**MEETING OF THE
PLANNING AND ZONING BOARD
QUASI-JUDICIAL PUBLIC HEARING**

February 21, 2017

**TOWN OF BAY HARBOR ISLANDS
COMMUNITY DEVELOPMENT
MEMORANDUM**

Subject: Site Development Plan Application
 30 DU Multi-Family Residential Complex
 9880-9900 W. Bay Harbor Drive
 Bay Harbor Islands Acct. No. MB2016-142
 MMPA Acct. No. 01-0702-1044

LANDSCAPE PLAN

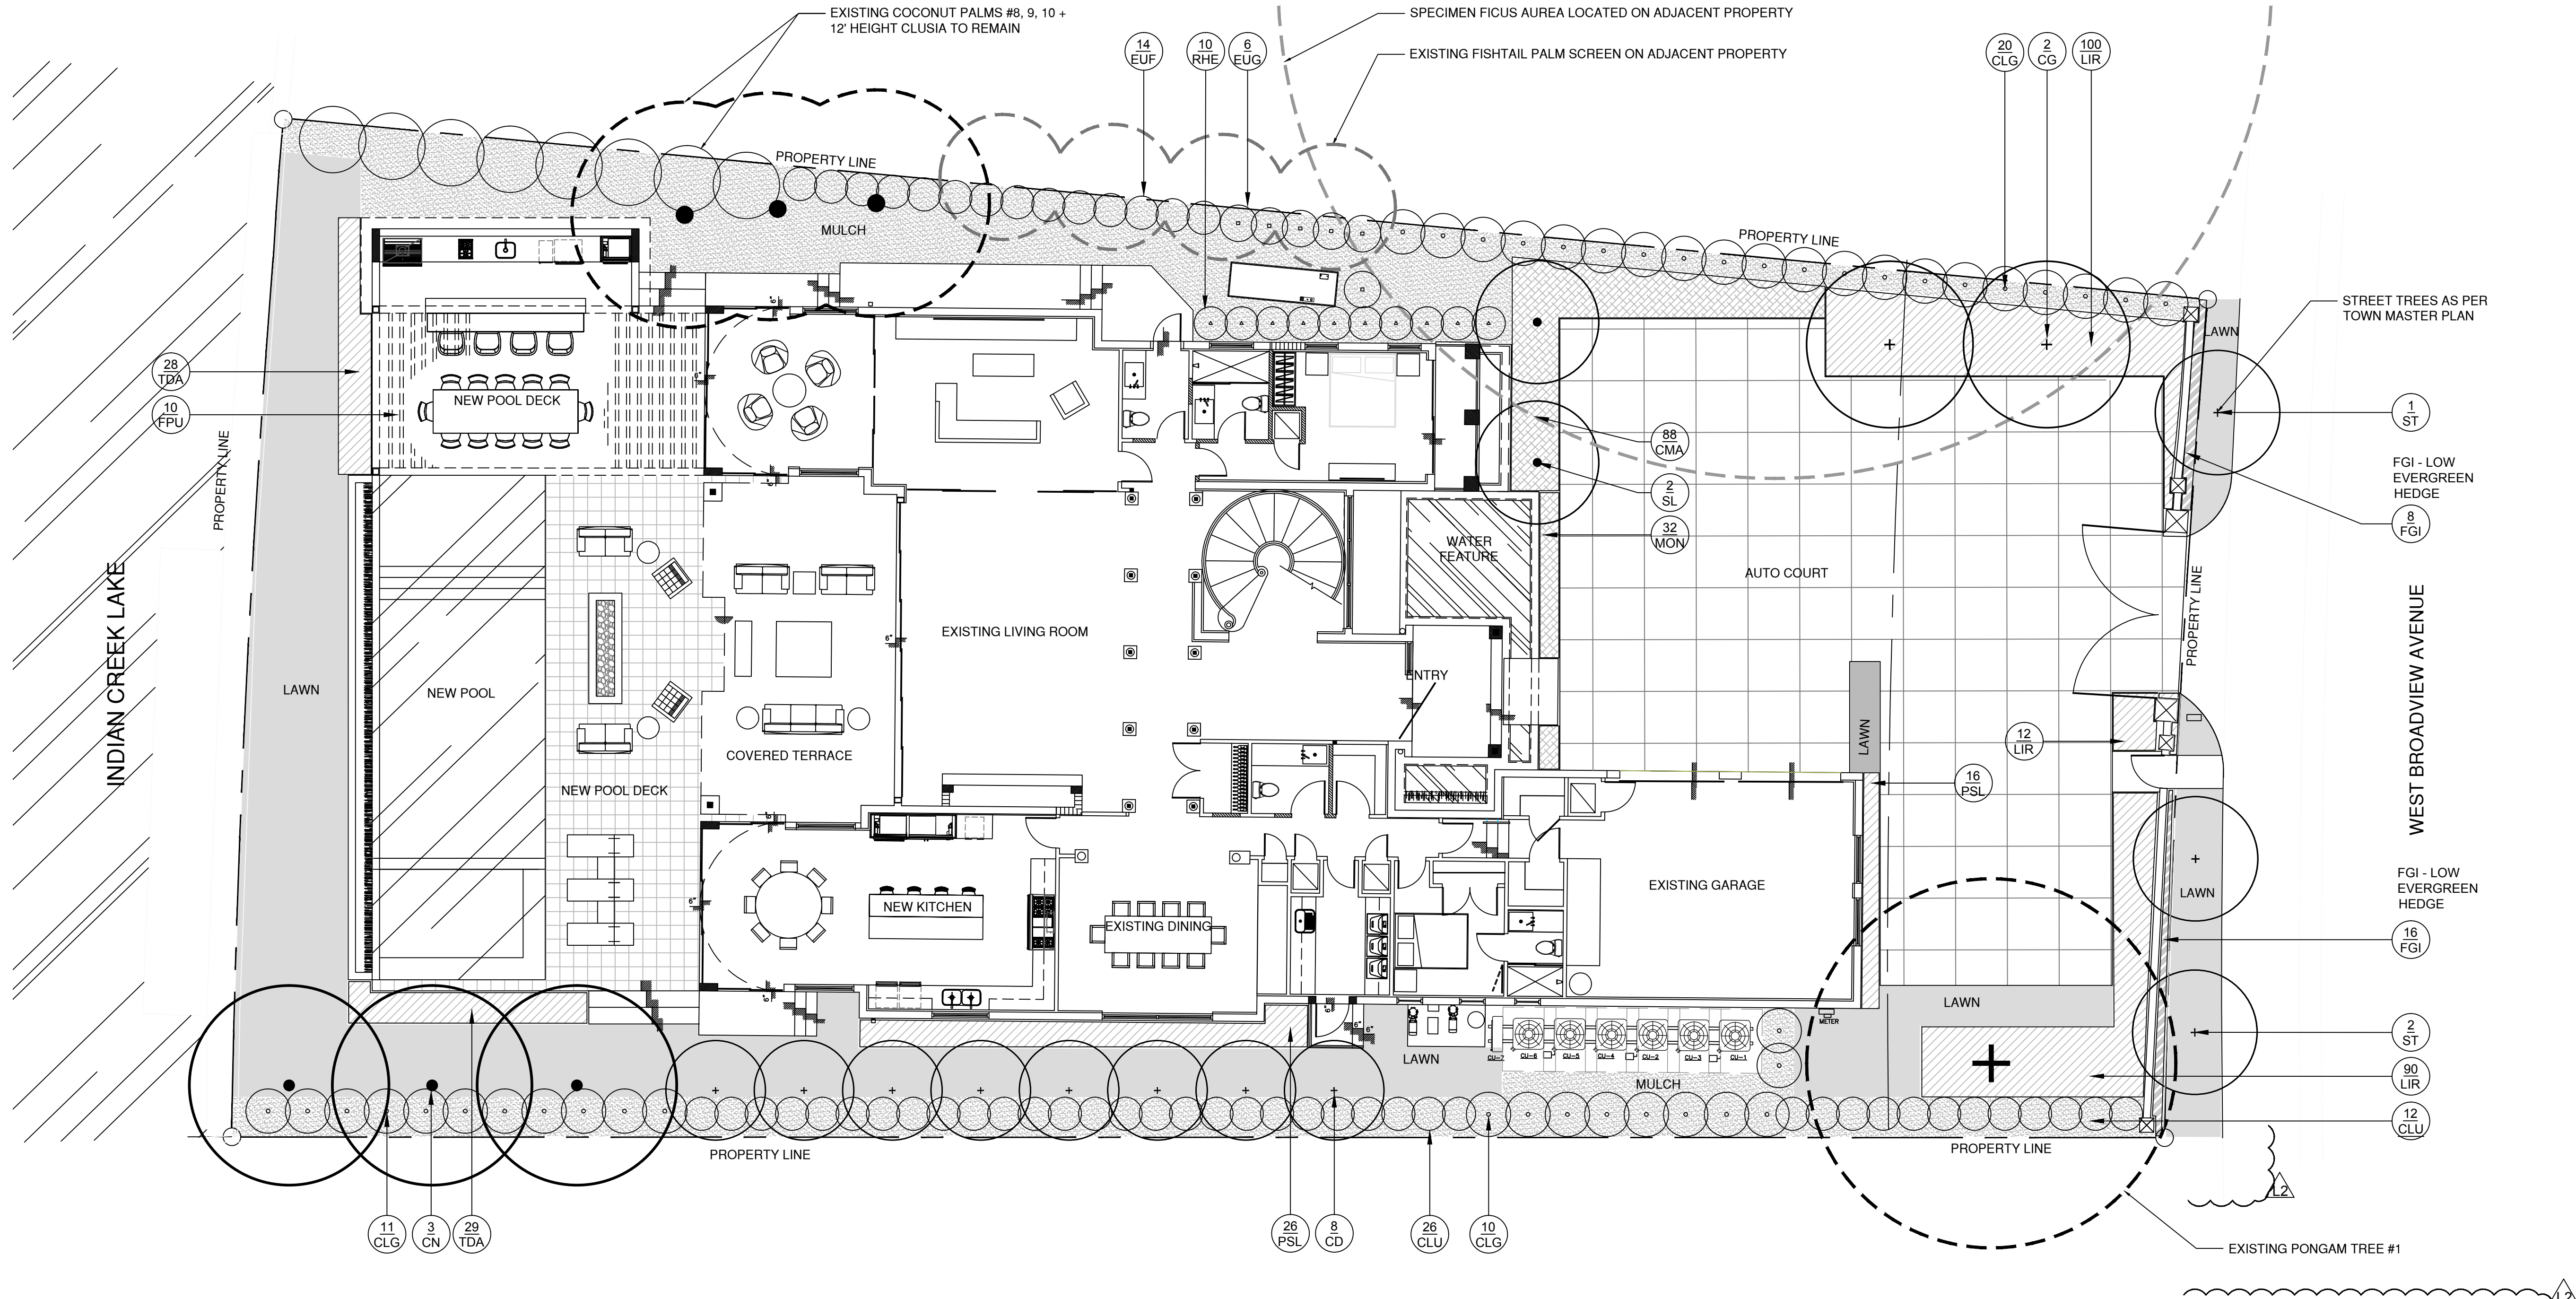
REV L2 - DRC COMMENTS DATED 06.16.15
1. The provided column in the landscape template is revised to show the numbers to the correctly corresponding lines.
2. The generator is fully screened from view by 8' height at time of planting Spanish Stopper shrubs. An additional 8' Spanish Stopper is provided to screen the view from the street.
3. The A/C and pool equipments are fully screened from view by 6' height at time of planting Clusia Shrubs.
